STATE OF FLORIDA DEPARTMENT OF TRANSPORTATION

## PUBLIC SIDEWALK CURB RAMPS

INTERIM STANDARD

THIS SHEET REPLACES INDEX NO. 304 (SHEET 10F 5) OF THE DESIGN STANDARDS, BOOKLET DATED JANUARY 2002.

## CURB RAMP DETECTABLE WARNING

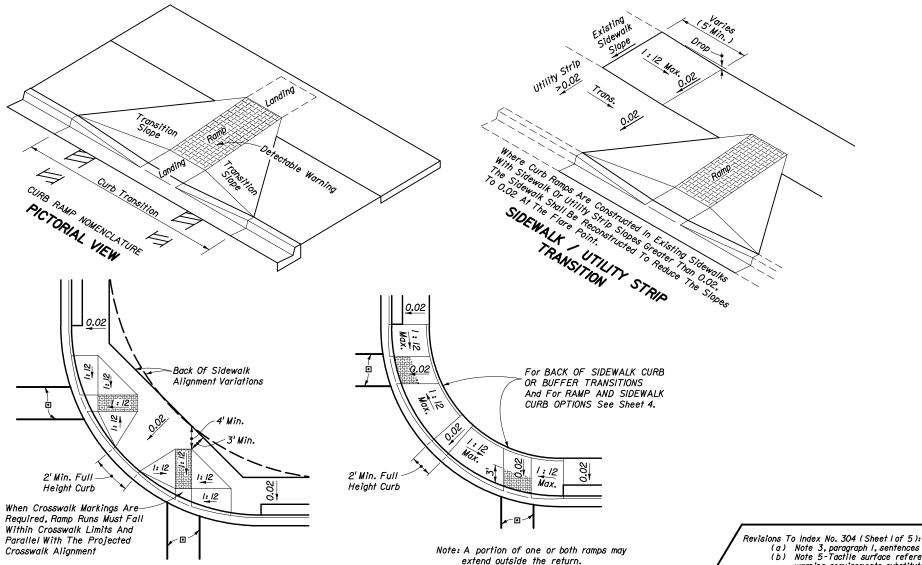
- Note 3, paragraph I, sentences 3 and 4- Sentences deleted. Note 5-Tactile surface references deleted and detectable
- warning requirements substituted.
  (c) Pictorial View-Ramp surface notation revised.
- (d) 'CURB RAMP DETECTABLE WARNING' detail added.

- 5. When perpendicular curb ramps abut the back of curb a detectable warning shall be applied to the full width and length of the ramp. When landings of parallel curb ramps abut the back of curb the detectable warning shall extend full width and 3' back of the curb. The detectable warning on curb ramps for linear pedestrian traffic and for corner ramps under conditions of infeasibility are to conform with the details in this Index for those specific ramp types. Detectable warnings shall be constructed by texturing a truncated dome pattern in conformance with U.S. Department of Justice A.D.A. Standards For Accessibe Design, A.D.A. Accessibility Guidelines, Section 4.29.2, (detail shown above left). Transition slopes are not to have detectable warnings.
